SUM "Headphone Hum" Workaround

IC8 - LM386

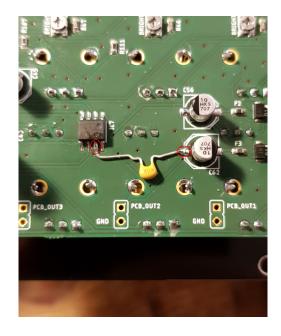
Solder a 100n capacitor between pin 7 and pin 4
